RE: City of Minturn Waste Water Collection System

Satellite Collection System of Hoxie (AR0020141)

On September 15, 2010, Brent Walker and I performed an inspection of the waste water collection system in accordance with the provisions of the Federal Clean Water Act, the Arkansas Water and Air Pollution Control Act, and the regulations promulgated thereunder. This inspection revealed the following violations:

A view of a broken cover over the sewer line running parallel with County Road #712 a few feet south of Pump Station #2 above.

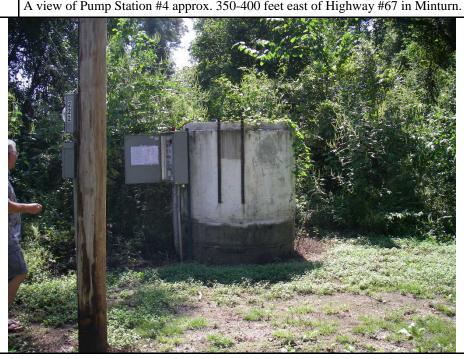
- a. The Auto System was not operational and the pumps had to be started manually.
- b. Only one of two pumps at the station was operational at the time of the inspection.
- c. The cover over the sewer line running parallel with County Road #712 was not sealed properly. The grout around the cover was missing in one section, thus allowing inflow and outflow of liquid. This line is located approximately 20-25 feet south of this pump station.

- c. In regards to the missing section of grout, a new seal has been obtained and has been installed. The city of Hoxie donated a used grout ring, so no cost was associated with this repair.
